ADDENDUM NO. 2

February 23, 2022

**DOUGLAS MACARTHUR ELEMENTARY SCHOOL ADDITIONS,
RENOVATIONS, AND RELATED WORK
Crown Point, IN 46307**

This Addendum consists of Pages ADD 2-1 through ADD 2-2 and attached Addendum No. 2 from Gibraltar Design dated February 21, 2022 and consisting of 7 pages, Specification Section 12 25 00 - Roller Shades and 52 drawings.

WALL SECTION
SCALE: 3/4" = 1'-0"

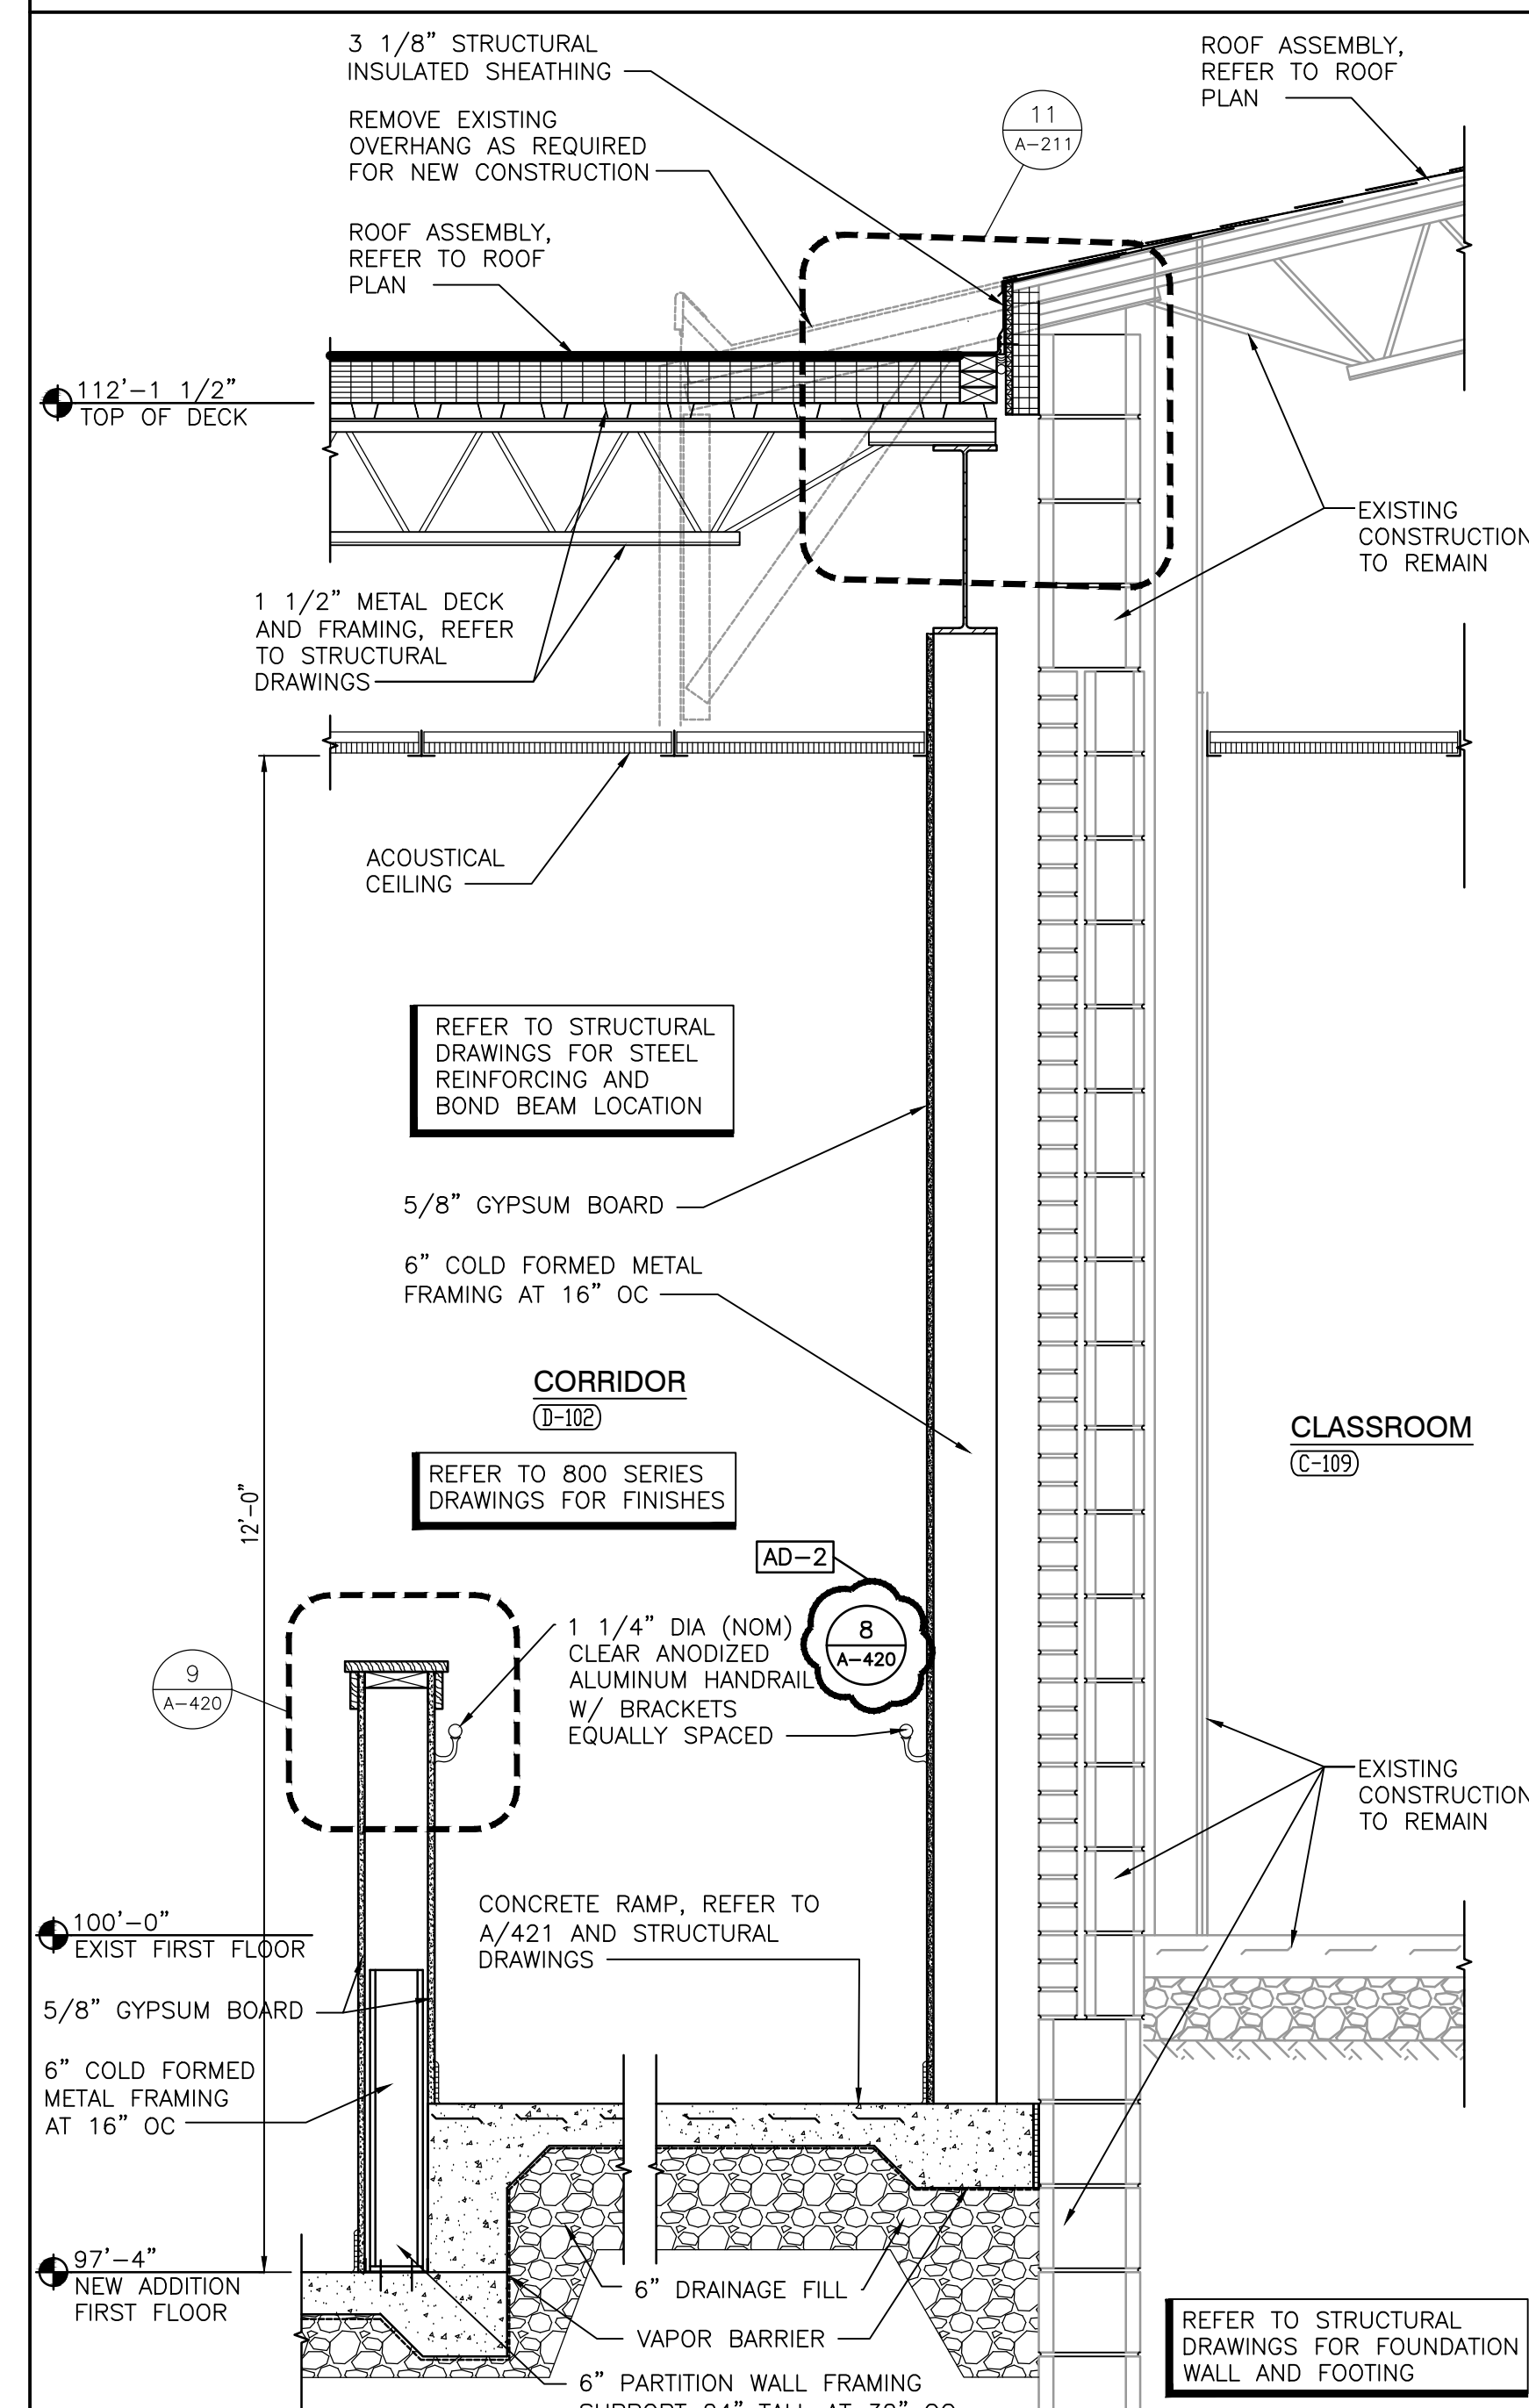
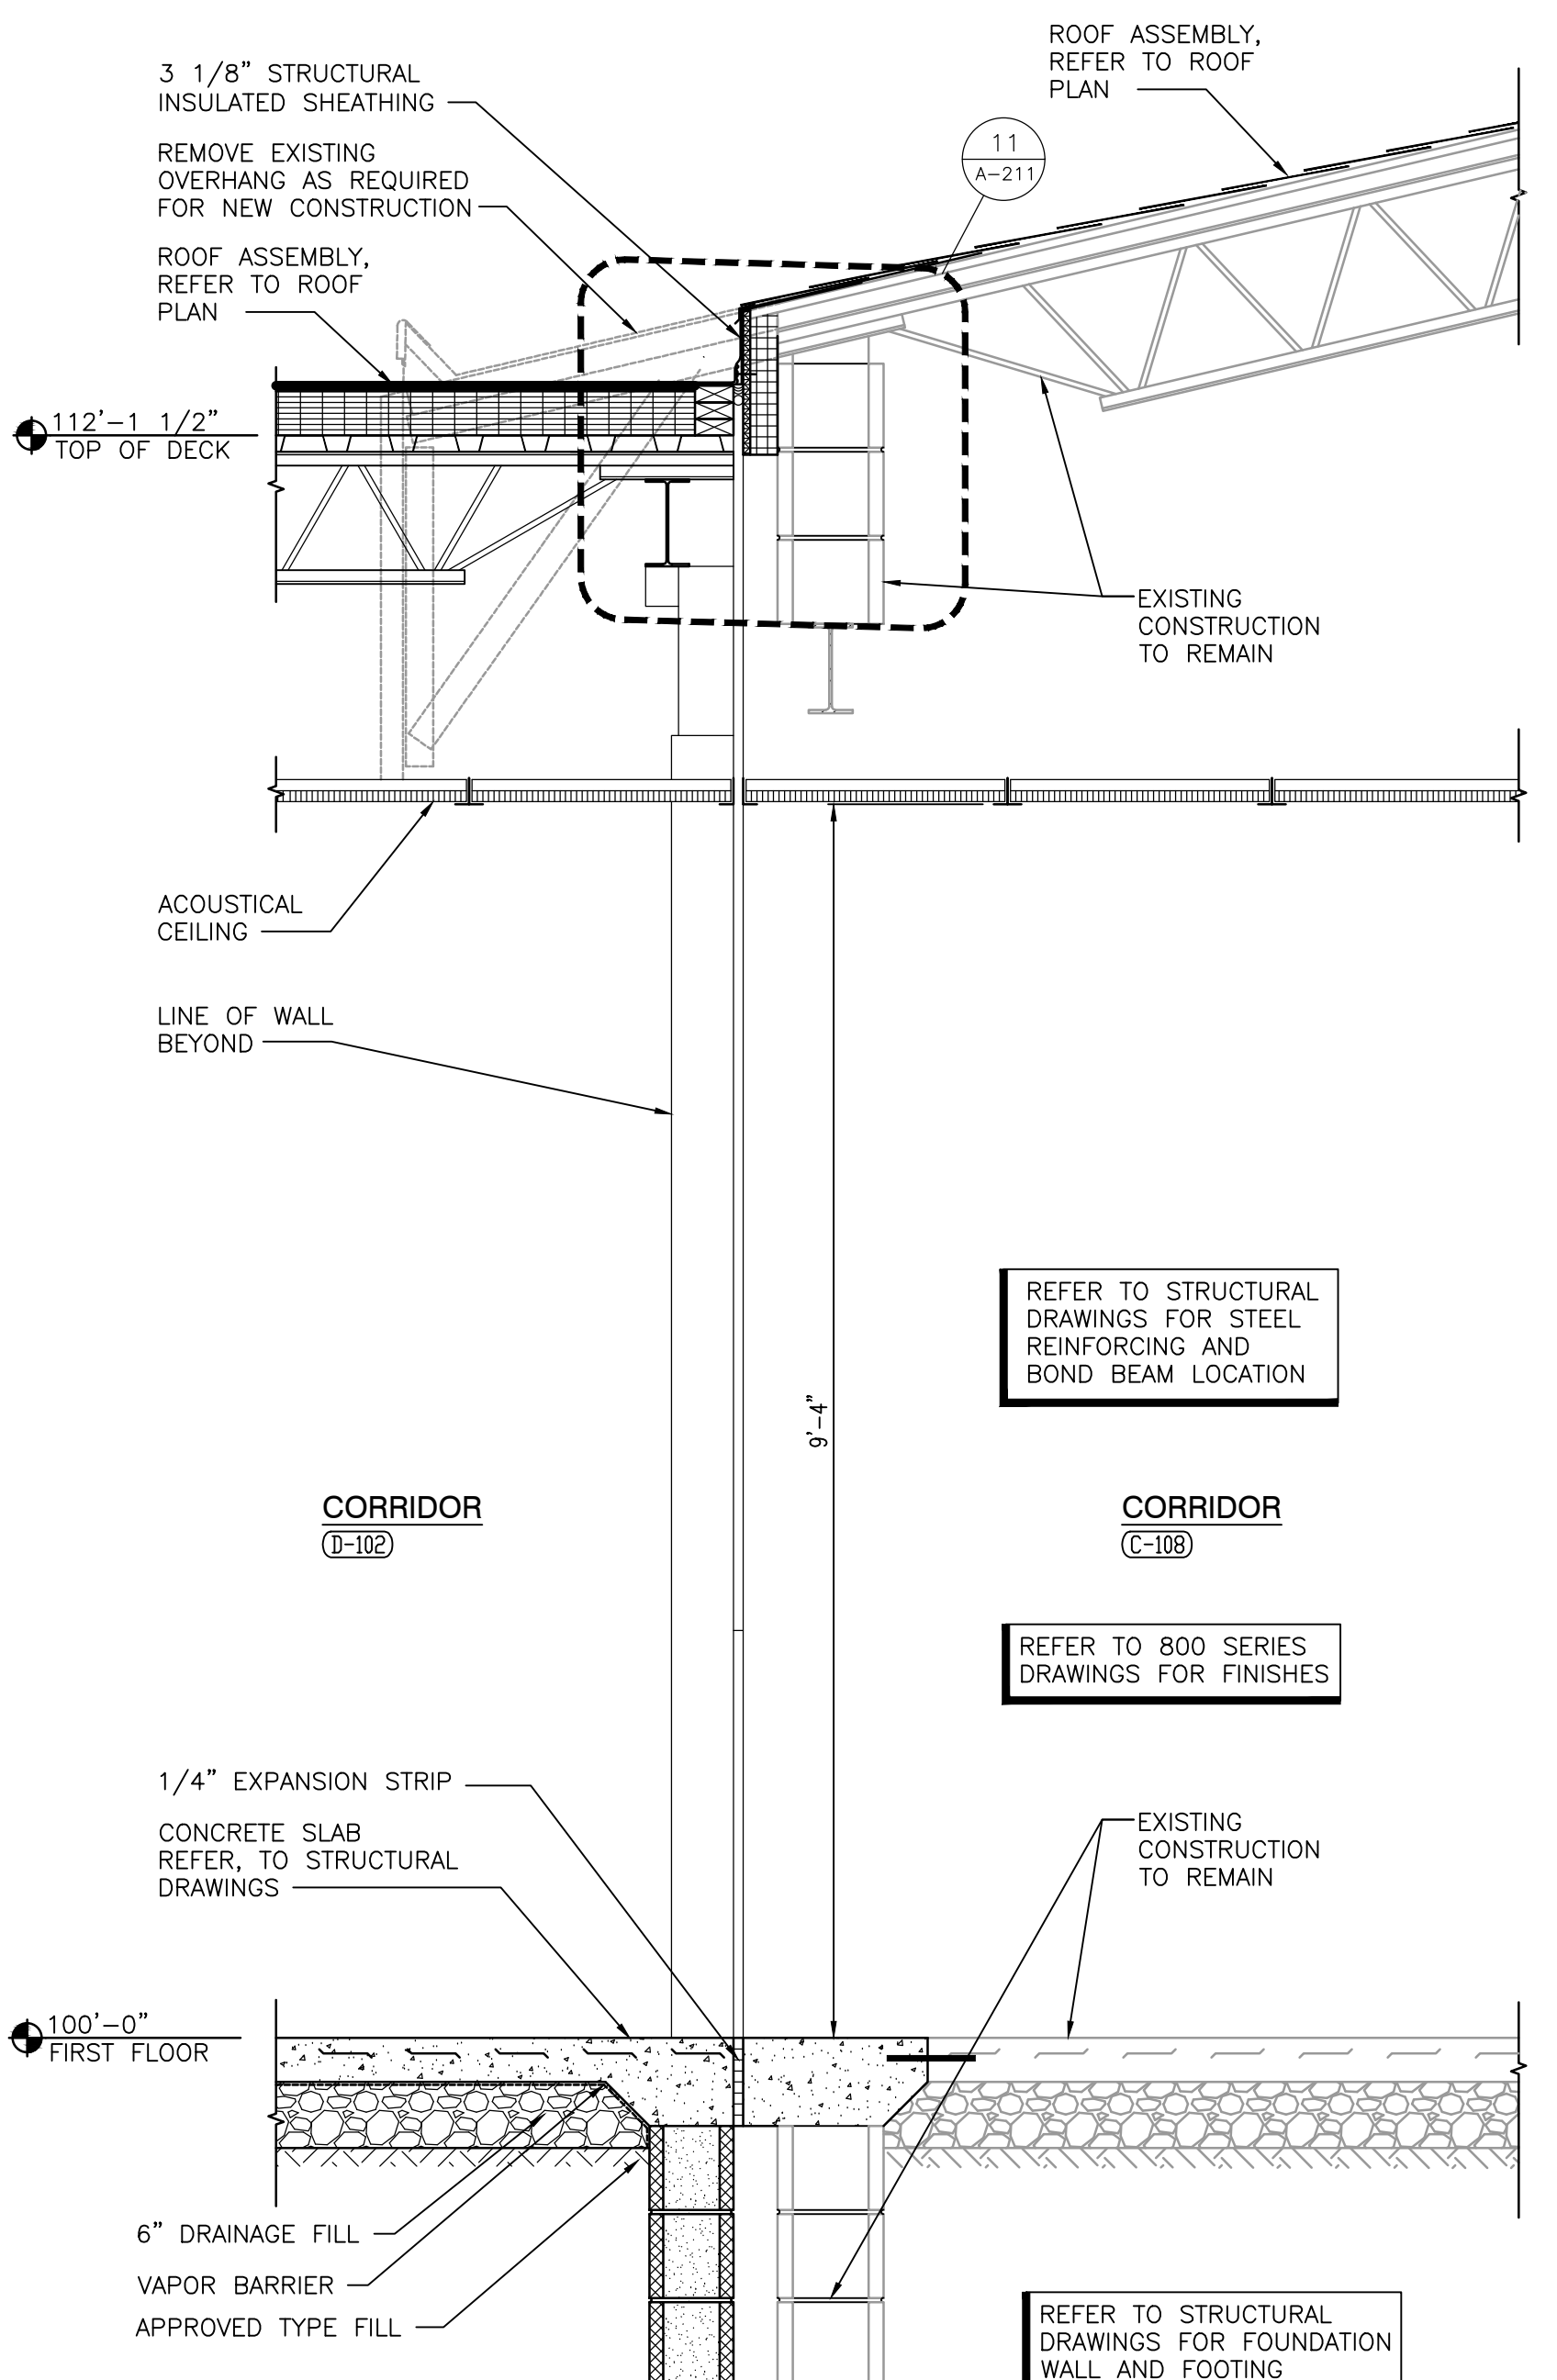
- A. Refer to revised, full size drawing, included in this Addendum, for the following revisions:
 - 1. Revise Reference bubble on 2/A-408
 - 2. Revise Wall section 4/A-408 with the two plan details to be 5/A-408 and update notes.
